Regional Review Finding Development of Regional Impact

RE: Development of Regional Impact (DRI) Review

Name of Proposal: SRM Concrete Ready Mix Plant DRI 4487

**PROPOSED
SITE PLAN
GRTA DRI# 4487**

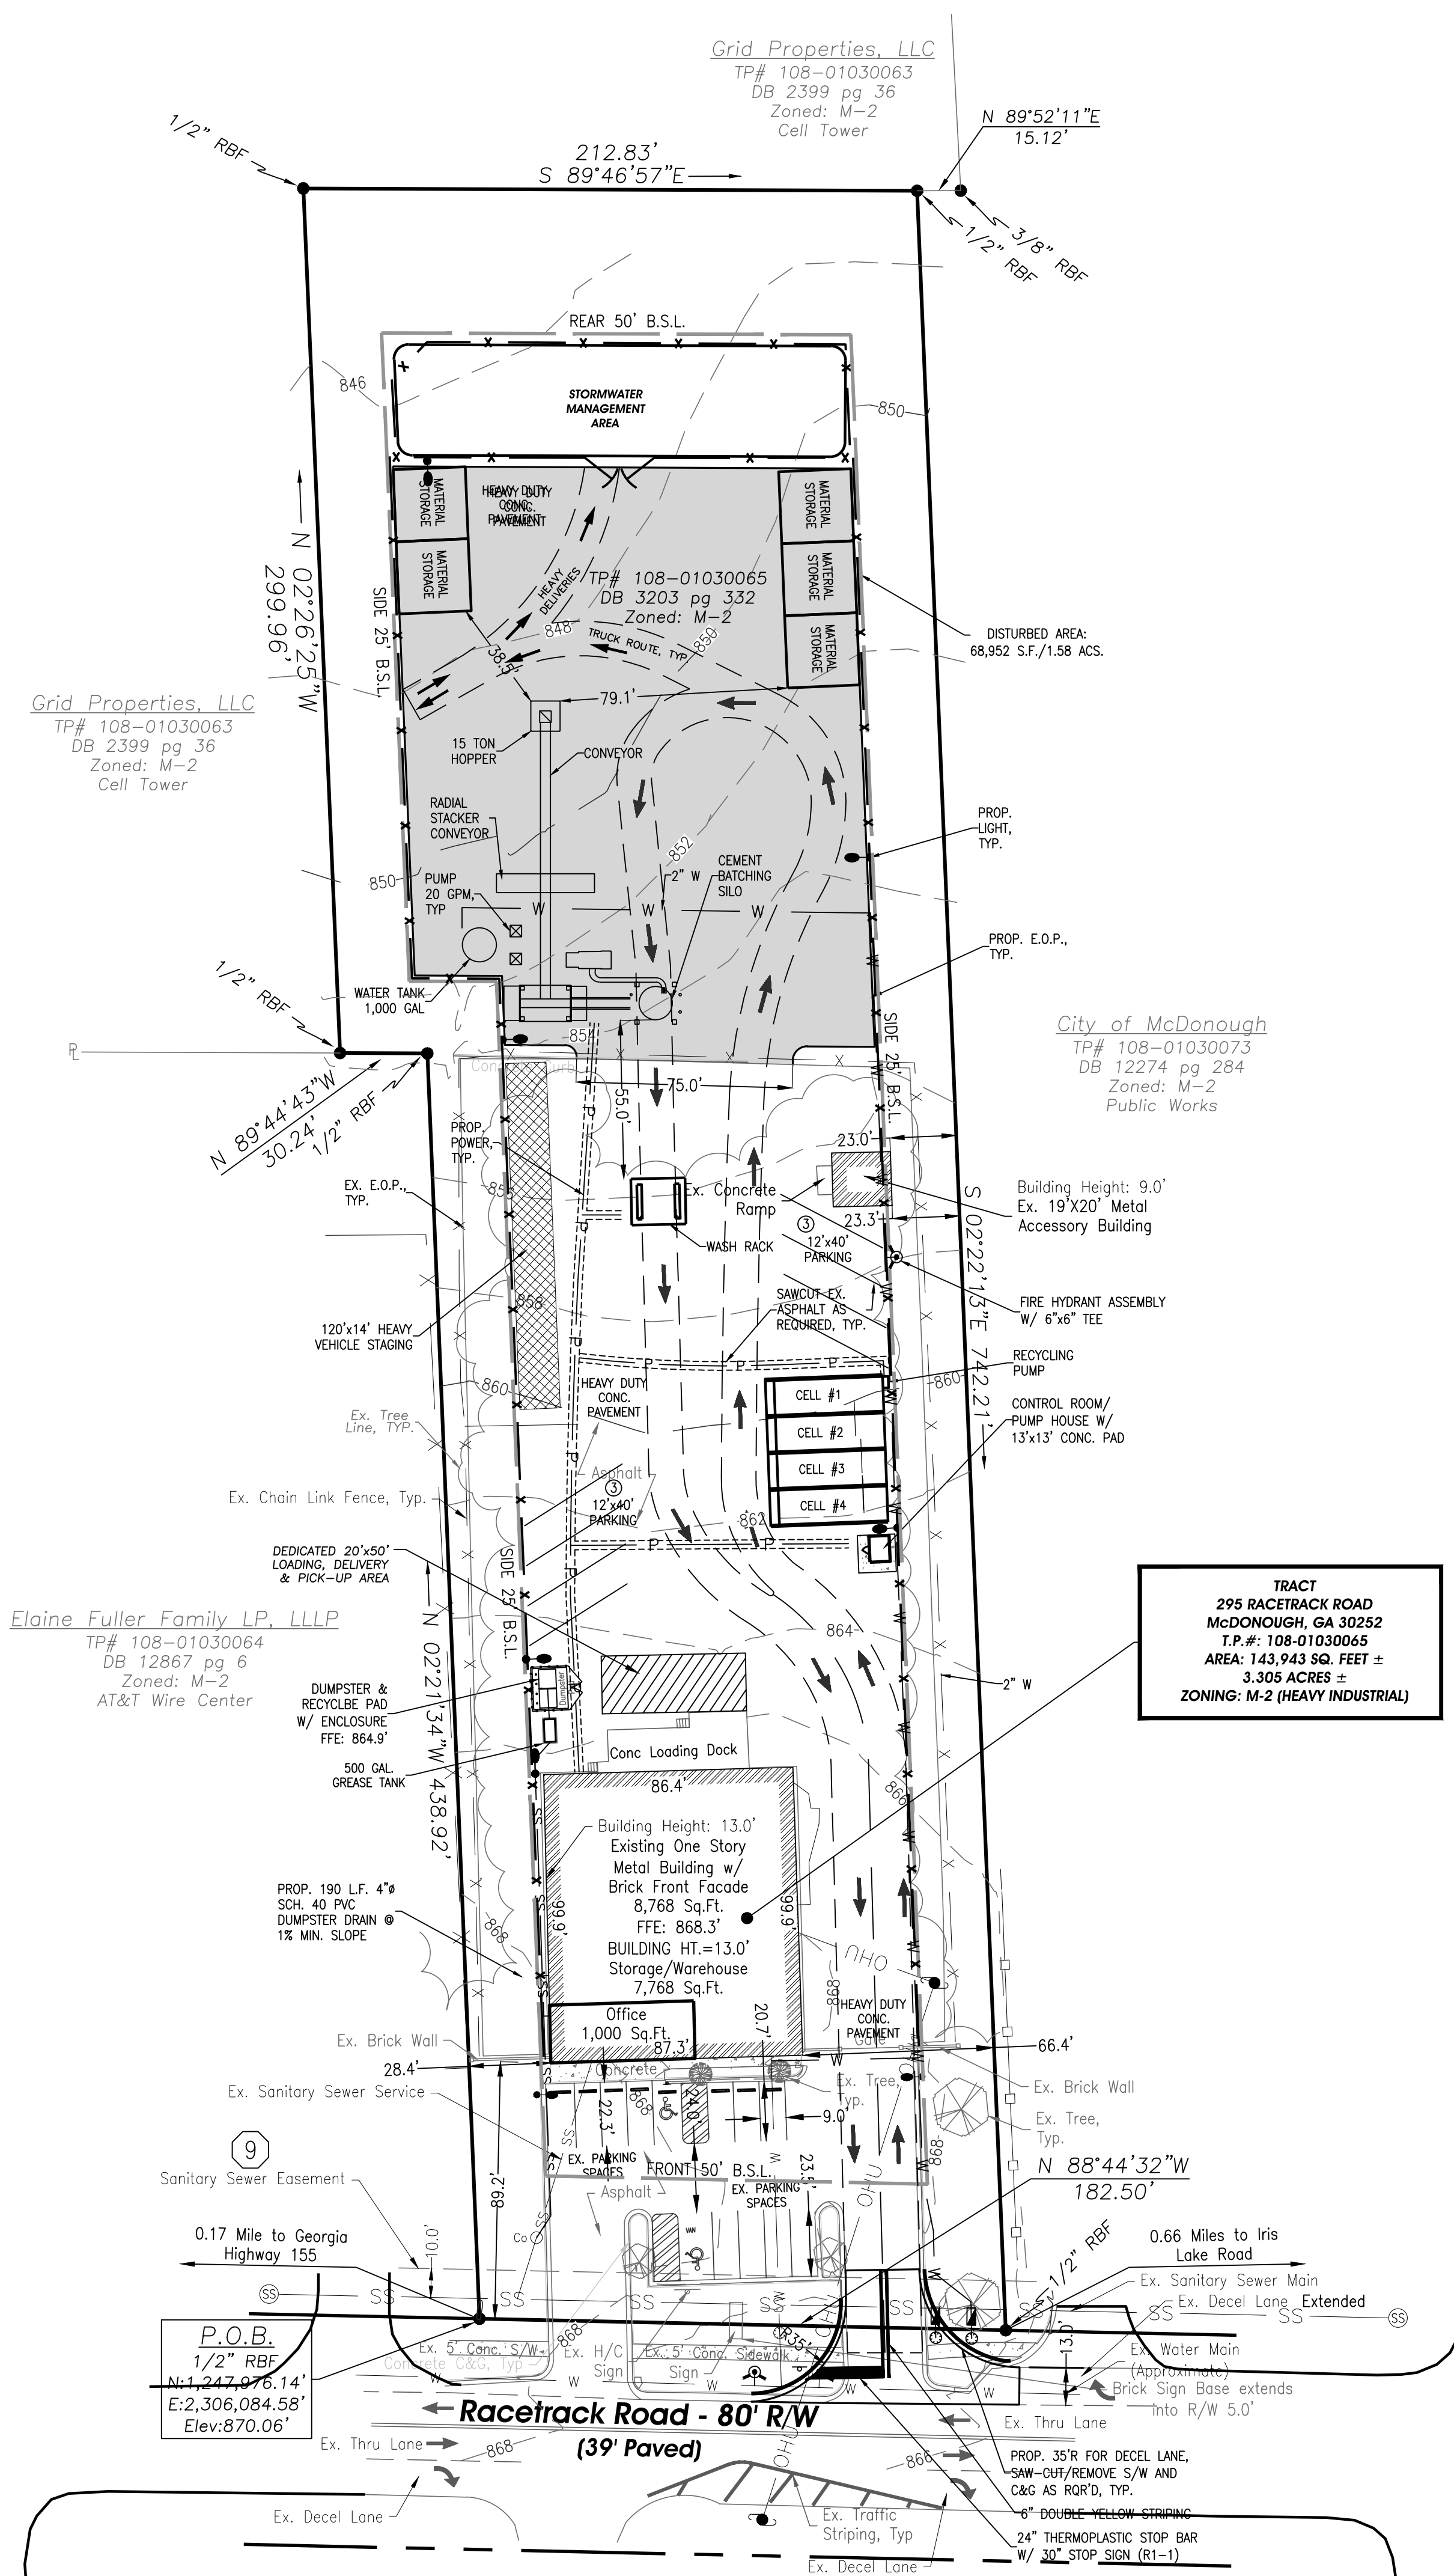
It is recommended that the stormwater impacts be addressed through green infrastructure and other alternative elements to reduce the size of or eliminate the proposed stormwater pond at the rear of the property and thereby increase the number of trees retained to provide a strong visual, sound, and dust buffer for the residential area to the north.

It is recommended that the stormwater impacts be addressed through green infrastructure and other alternative elements to reduce the size of or eliminate the proposed stormwater pond at the rear of the property and thereby increase the number of trees retained to provide a strong visual, sound, and dust buffer for the residential area to the north.

**PROPOSED
SITE PLAN
GRTA DRI# 4487**

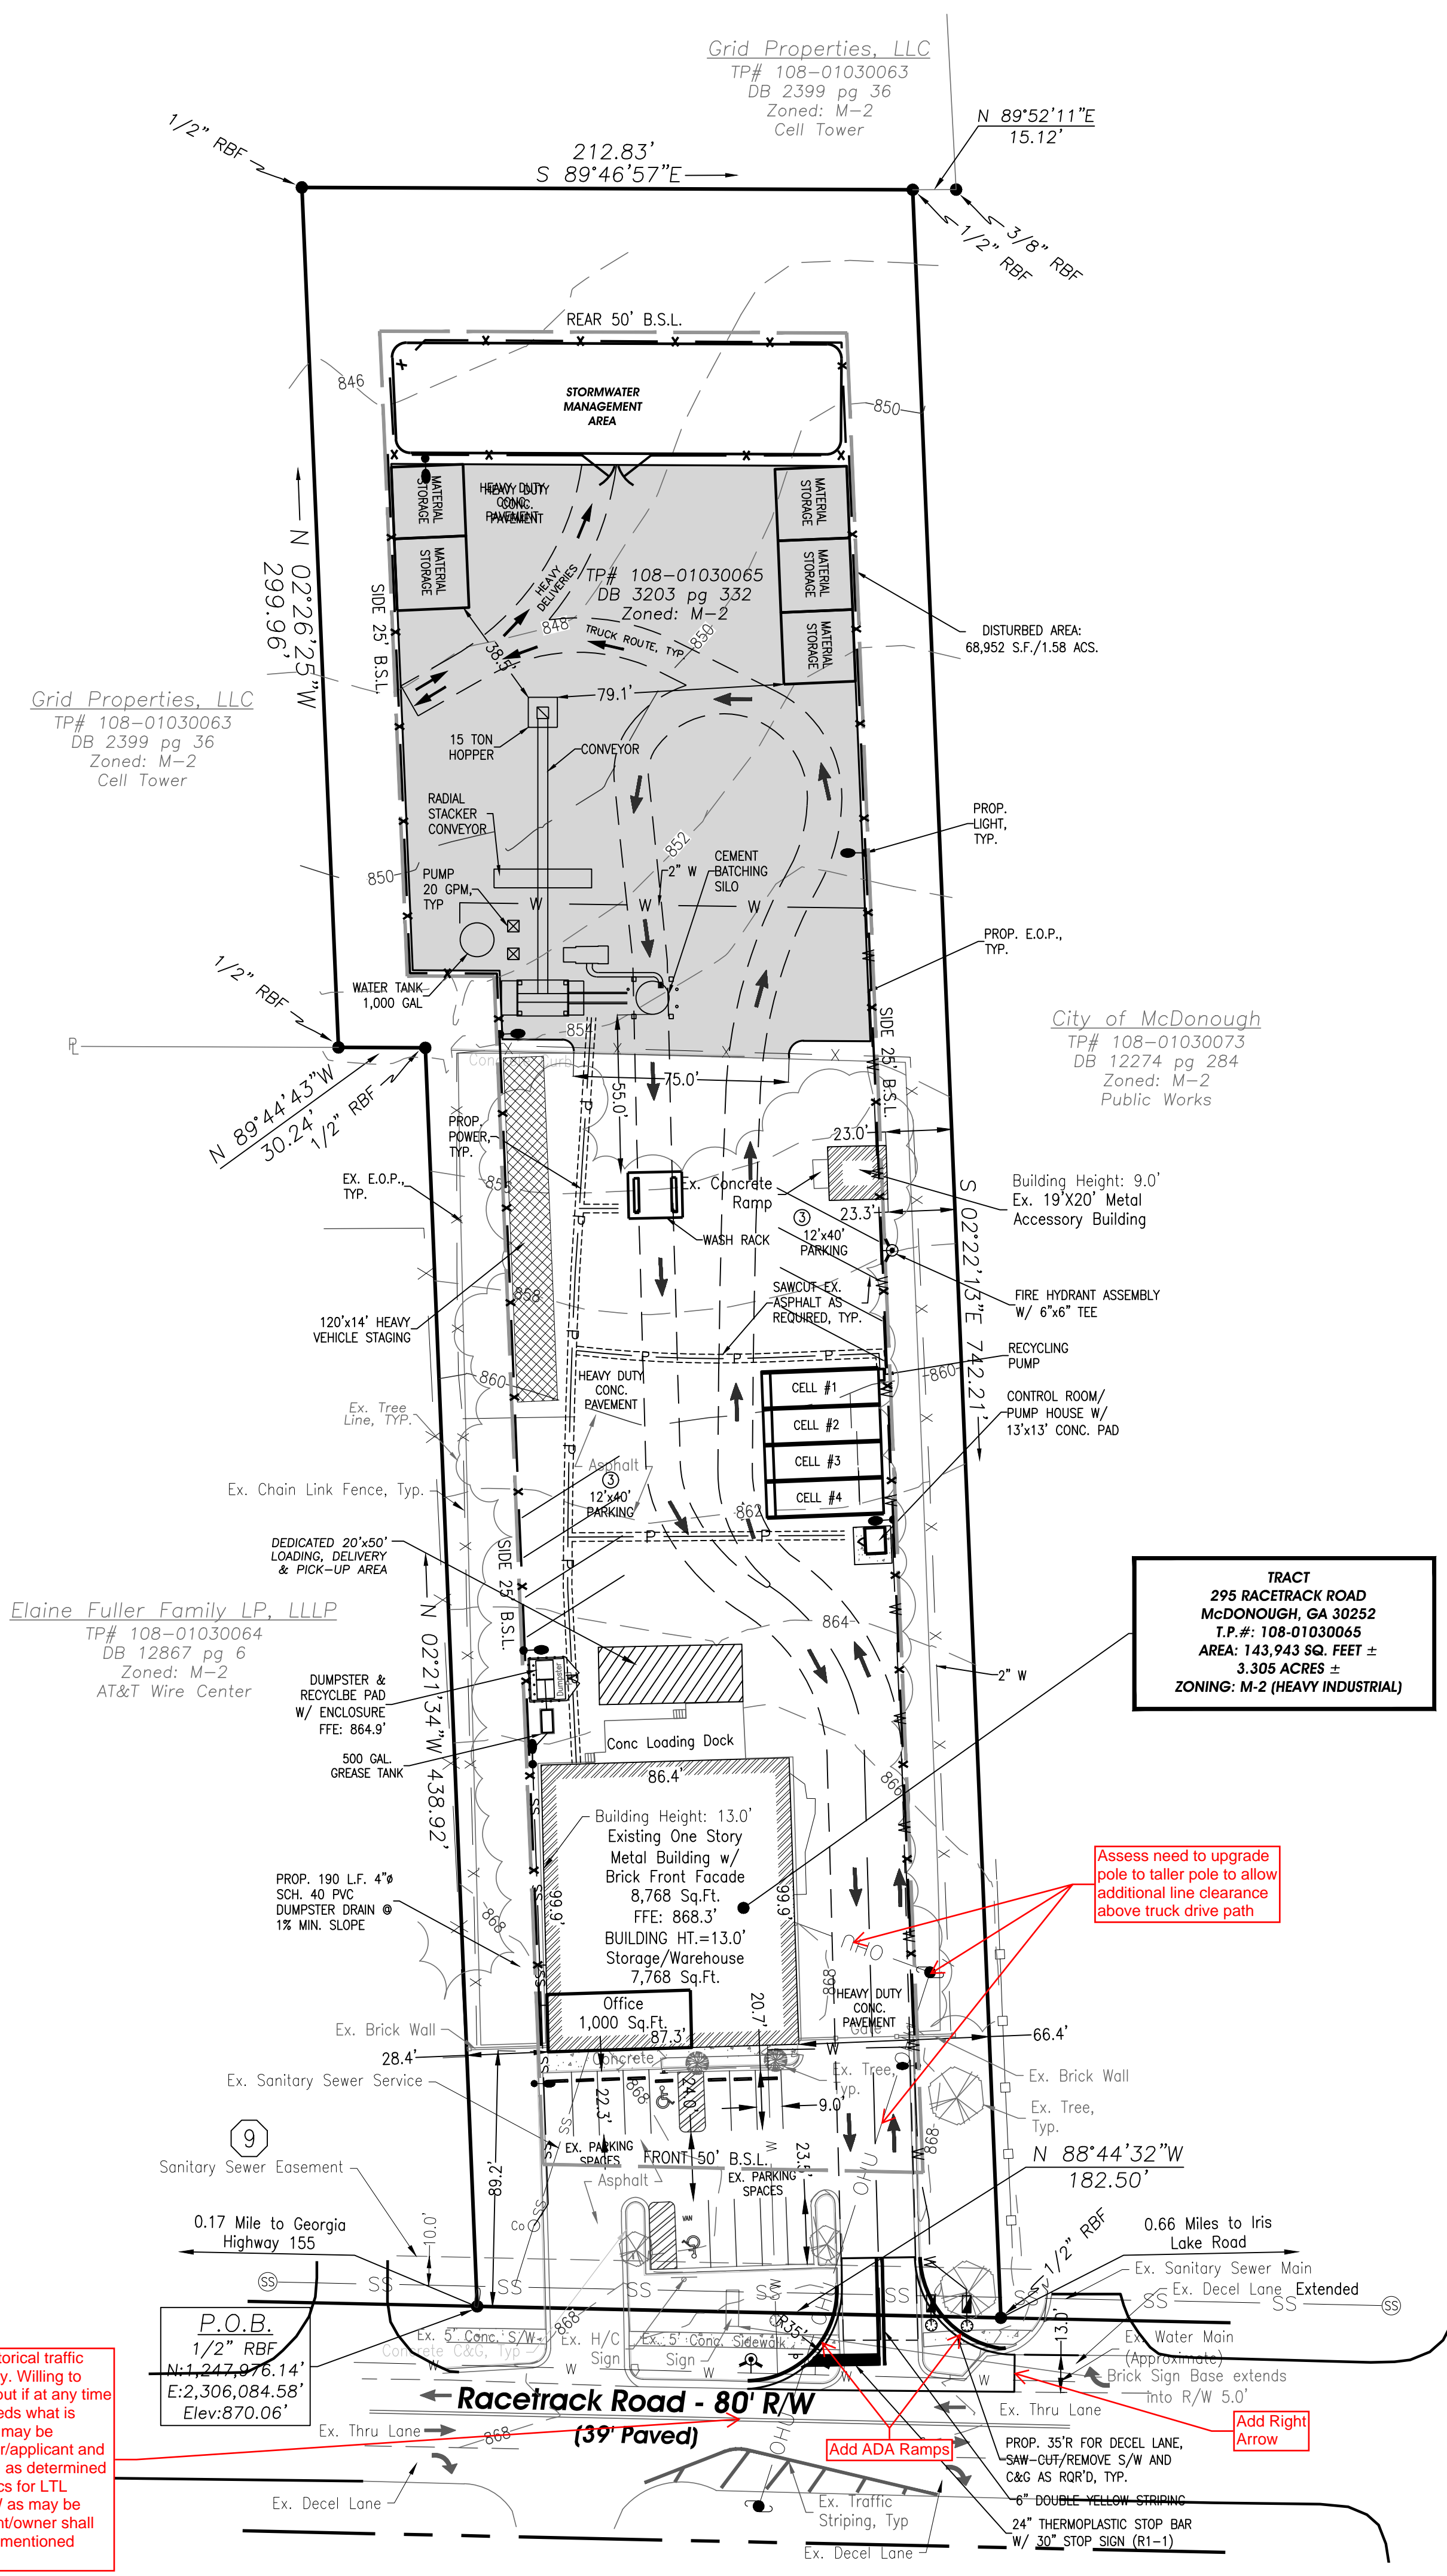
Assess need to upgrade pole to taller pole to allow additional line clearance above truck drive path

Add ADA Ramps

Add Right Arrow

Fully examine proposed ITE traffic counts vs historical traffic data for similar location owned by same company. Willing to accept proposed trips per day data at this time, but if at any time in the future the traffic created by the plant exceeds what is proposed (on a continued basis), a left turn lane may be required to be constructed, at that time, by owner/applicant and at no cost to HCDOT or City of McDonough, and as determined by DOT Engineer. LTL shall meet all GDOT specs for LTL spacing, tapers, and storage, as well as all ROW as may be necessary to facilitate LTL construction. Applicant/owner shall bear total and financial responsibility for all aforementioned work, if required.
